RE: St. Lucie Unit 2
Docket No. 50-389
Proposed License Amendment
WCAP-9272 Reload Methodology and
Implementing 30% Steam Generator Tube Plugging Limit

Pursuant to 10 CFR 50.90, Florida Power & Light Company (FPL) requests to amend Facility Operating License NPF-16 for St. Lucie Unit 2. The purpose of this proposed license amendment is to allow operation of St. Lucie Unit 2 with a reduced reactor coolant system (RCS) flow, corresponding to a steam generator tube plugging level of 30% per steam generator. The re-analysis performed to support this reduction in RCS flow has used Westinghouse WCAP-9272, Westinghouse Reload Safety Evaluation Methodology. The implementation of these changes will require changes to the current Technical Specifications (TS).

The proposed amendment includes the following Technical Specifications changes: Revision to the Thermal Margin Safety Limit Lines TS Figure 2.1-1, reduction in RCS flow in TS Table 3.2-2 and in footnote to TS Table 2.2-1, changes to positive MTC in TS 3.1.1.4, changes to surveillance requirements for Linear Heat Rate TS 3/4.2.1, deletion of Fxy TS 3/4.2.2, relocation to COLR of DNB parameters in TS 3.2-5, changes to Design Features F

FIGURE 2.1-1: REACTOR CORE THERMAL MARGIN SAFETY LIMIT LINES
 FOUR REACTOR COOLANT PUMPS OPERATING

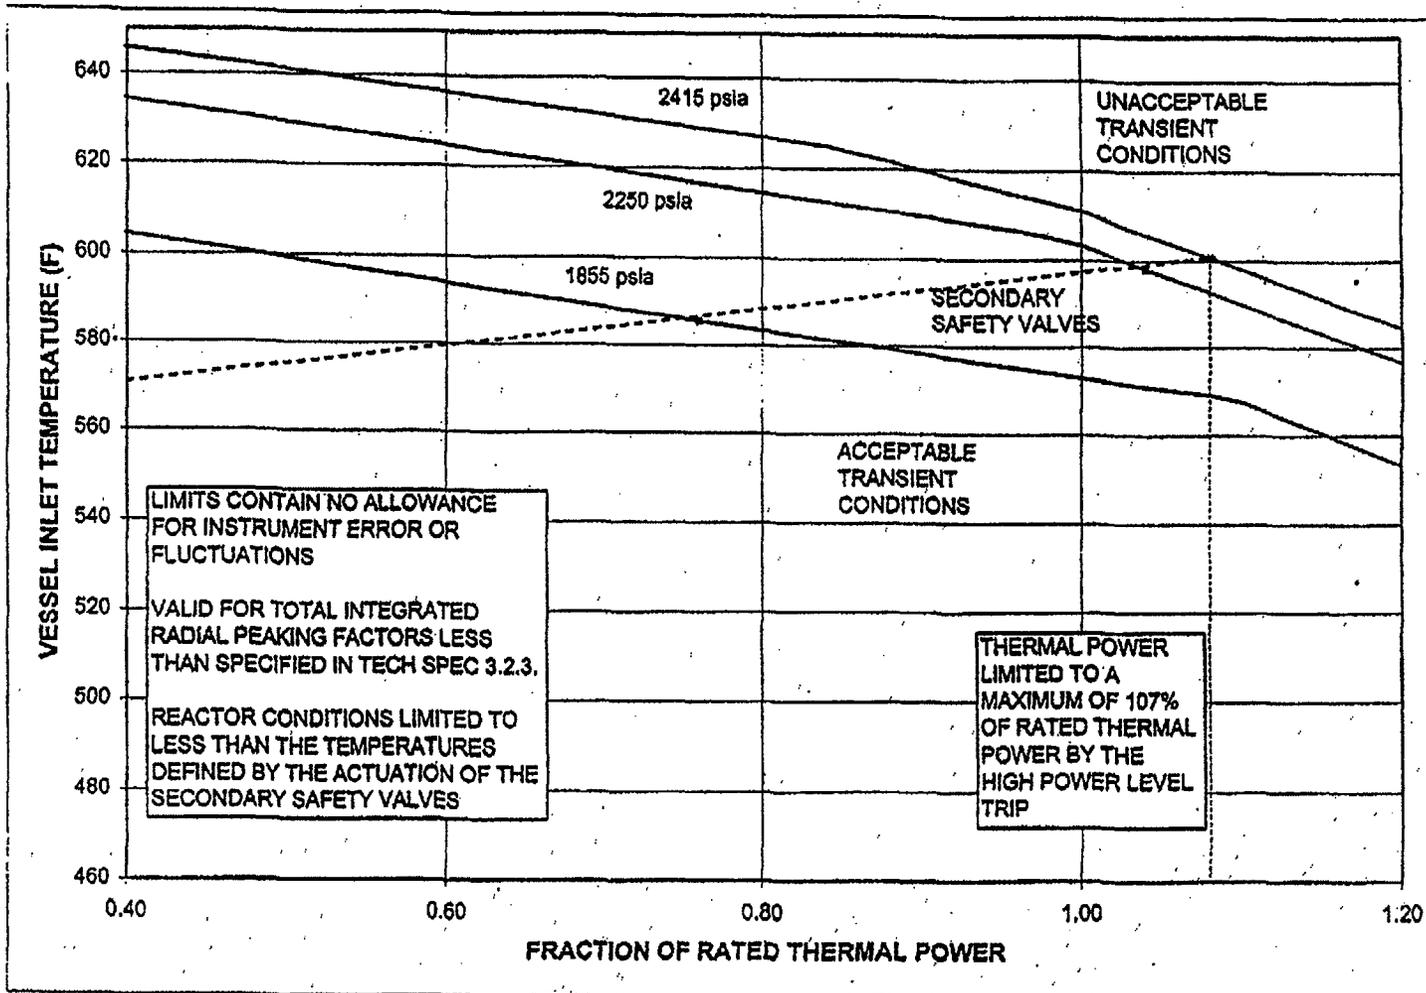
change to the TS Figure 2.1-1 is accompanied with a change to the TS Bases Figure B2.1-1.

- 2.2 TS Page 2-3, TS Safety Limit 2.1.1: (Reactor Core), Figure 2.1-1 Thermal Margin Safety Limit Lines and TS Bases Figure B2.1-1

TS Figure 2.1-1 is revised to reflect the reduction in RCS flow from 355,000 gpm to 335,000 gpm and the changes to the methodology. The revised TS basis Figure B2.1-1 reflects the axial shapes used in the generation of the DNB lines on TS Figure 2.1-1.

Figure A-1 Proposed AXIAL SHAPE INDEX Limits for Linear Heat Rate when Using Excure Detector Monitoring System (COLR Figure 3.2.2)

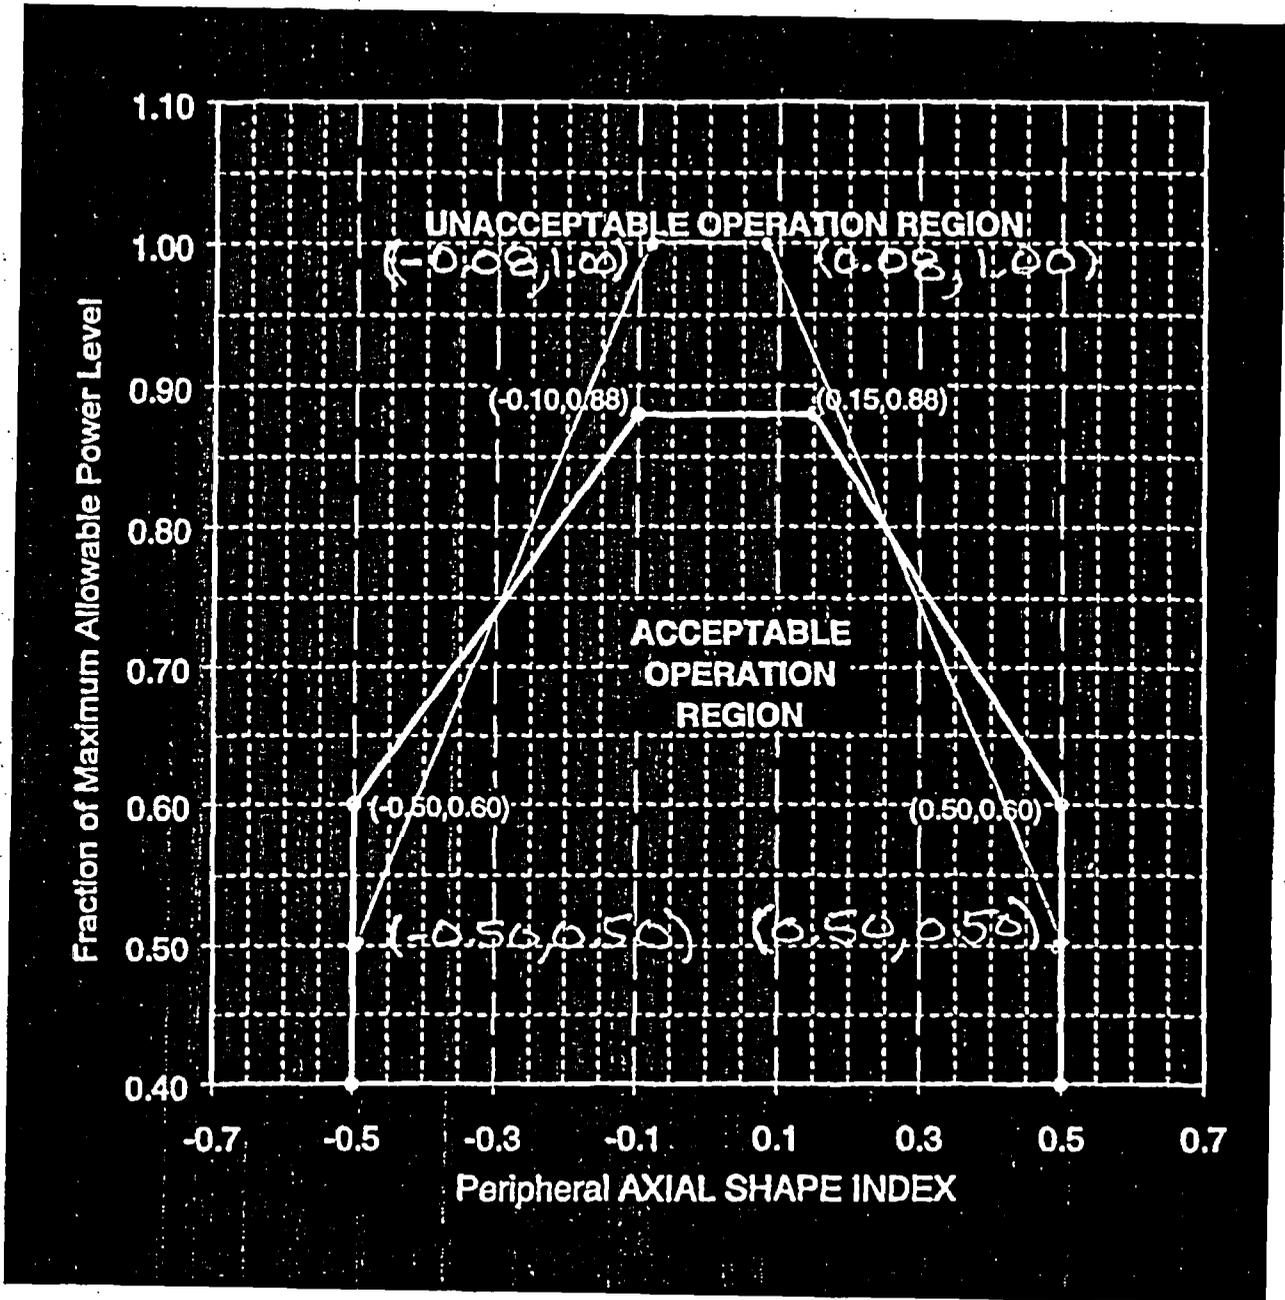
Note that future activities may result in relaxation of 12.5 kw/ft peak linear heat rate limit. Recalculation of the RAOC cases under a relaxed peak linear heat rate assumption could then serve as the basis for relaxation of the ASI limits for linear heat rate when using the EDMS, which would be implemented through the COLR on a cycle-specific basis.
